Docket Item # 14
BAR CASE #2008-0007

BAR Meeting
February 6, 2008

ISSUE: Demolition and Capsulation

LOCATION: 5 Potomac Court

Figure 1 - North elevation

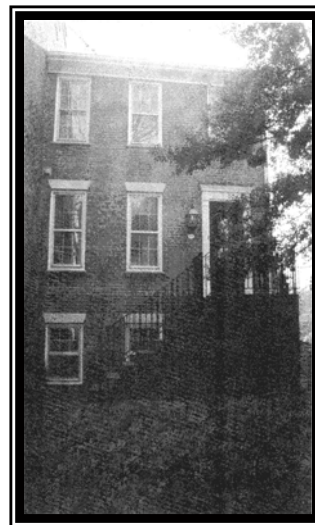
- 1) The front porch with the copper roof which interrupts the symmetry of the facade;
- 2) The dominant bay windows on the rear elevation. These drastically alter the appearance of the facade.
